**SECTION 00806**

**CHANGE ORDER**

No. Two (2) FINAL

OWNER St. Charles Parish Department of Public Works  
CONTRACTOR Cycle Construction Company, LLC  
Contract: P190507 Hydraulic Bottleneck Near Destrehan P.S. No. 2  
Project: Hydraulic Bottleneck Near Destrehan P.S. No. 2  
OWNER's Contract No. P190507 ENGINEER's Contract No. 2019-730  
ENGINEER Evans-Graves Engineers, Inc.

Line	Layer
Top line	Original Ground
Bottom line	Excavation shots
Bottleneck canal	Excavation quantities

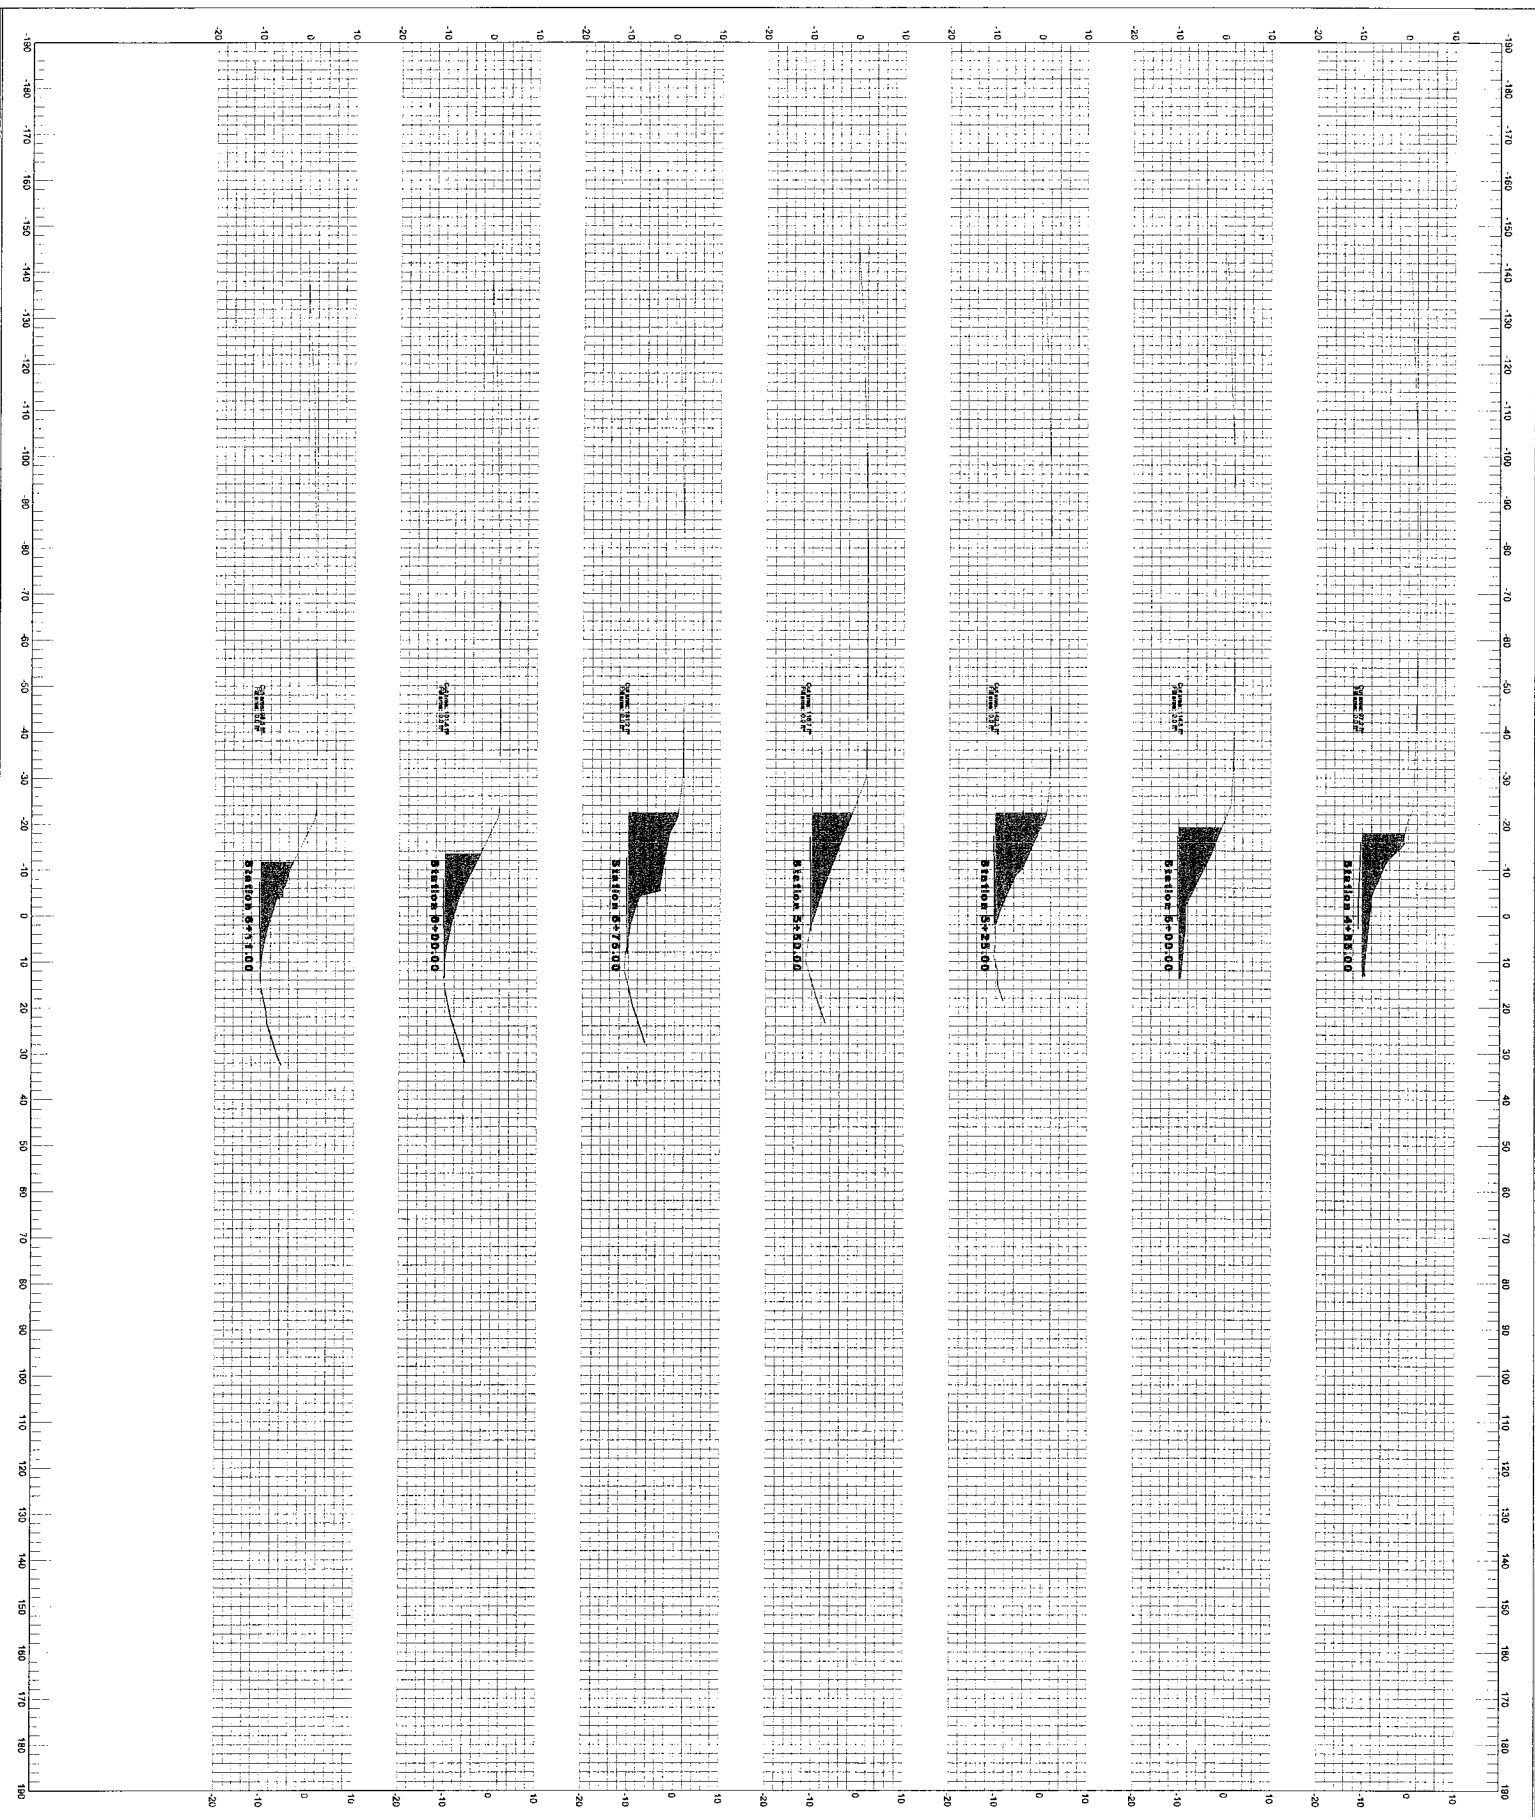
- a. Contract Item #3: Excavation

The quantity is to be increased from 1,232 Cubic Yards to 1,372.67 Cubic Yards, at the Contract unit rate of \$40/Cubic Yard *(+\$5,626.80)*

- a. The estimated bid quantity for this Work Item was based on an older (2019) topographic survey, and the Contractor's pre-construction survey was performed in 2023; so there was some inherent difference in the existing conditions of the Canal bottom and overall cross-section. Further, the shifting alignment of the west side sheet pile wall due to the pipeline owner coordination presented a non-uniform, non-parallel boundary on the west side which affected the calculation estimates. The excavation depth remained the same as designed, but the net result of the above two factors was an additional 140.67 CY of excavation being performed over what was estimated.
- b. This Work Item is a not-to-exceed allowance, and was not fully needed to complete the project.
